TOWN OF BROOKFIELD PLAN COMMISSION ZONING REPORT

RE: **Avery & Birch – Final Approval**
21055 Crossroads Circle BKFT1129999007

CONSTRUCTION PLANS
FOR
AVERY & BIRCH
21055 CROSSROADS CIRCLE
TOWN OF BROOKFIELD, WISCONSIN

DETAILS

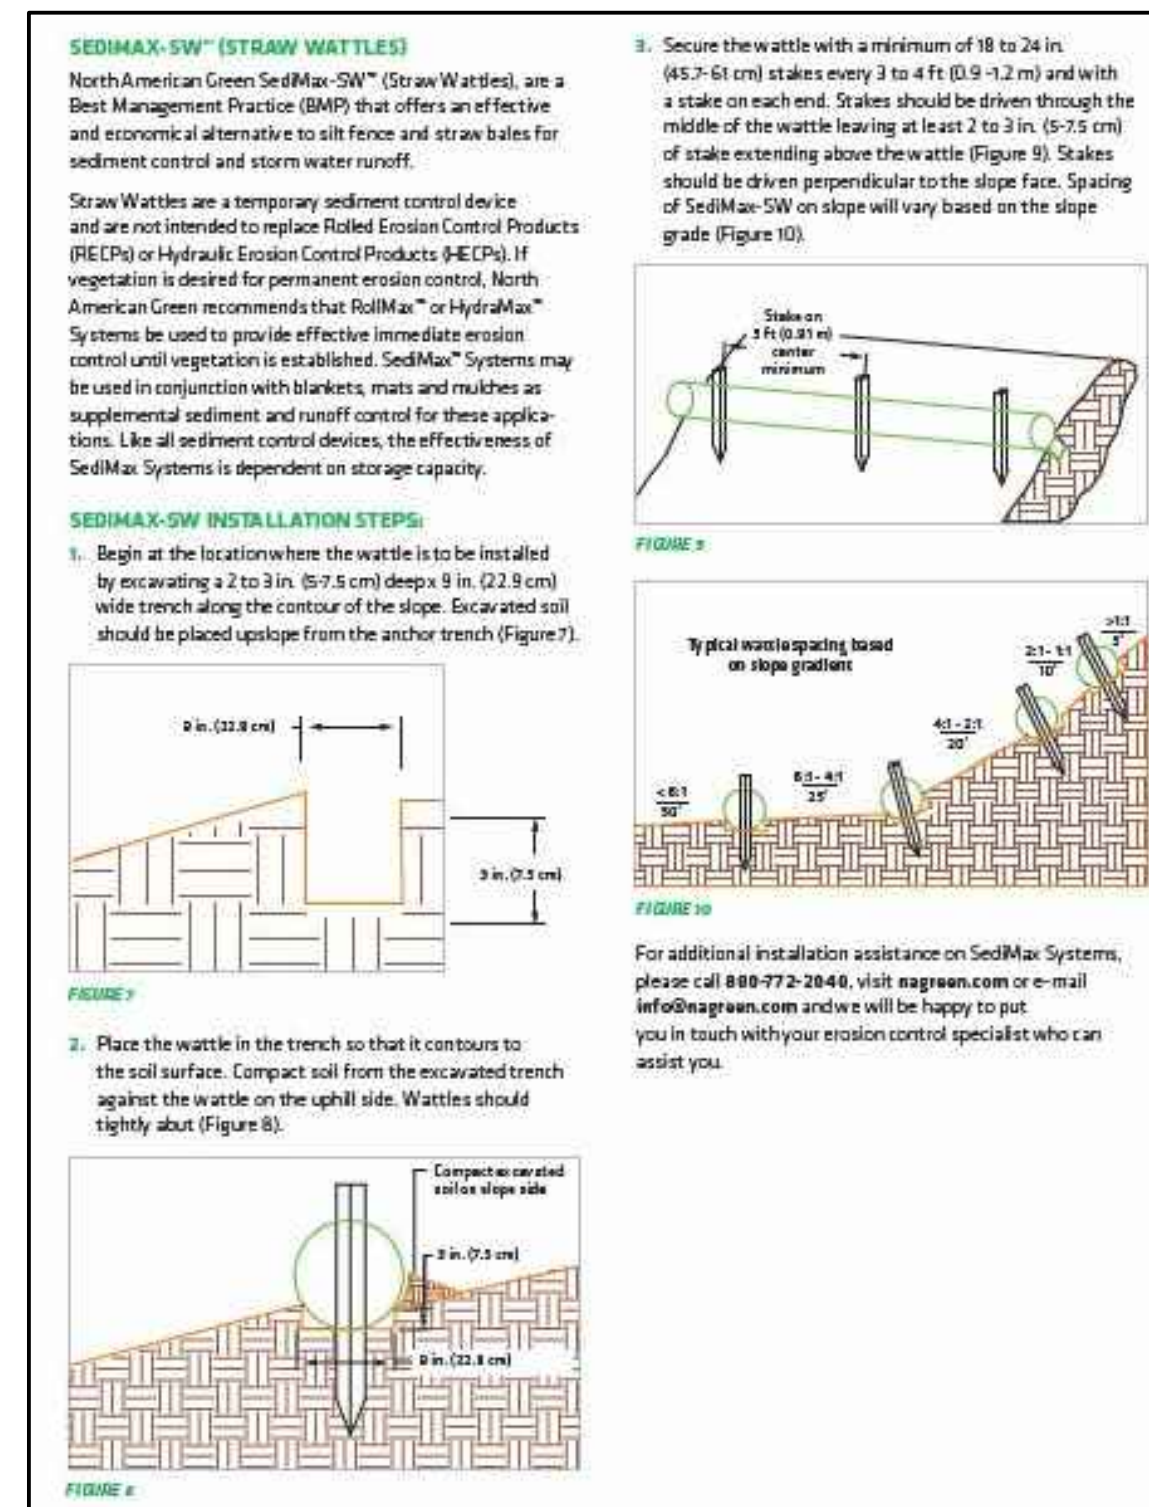
- The proposed 8" watermain and hydrant will become public, it should be noted and I believe a DNR approval will be needed.
- The "Hydrant Installation Figure 2" specifies a Ductile Iron Lead, we allow PVC.

- I would also like to know how close to the curb the hydrant will be located, if it's too close it may be difficult to access if there's a car parked and can be easily hit by snow plow.
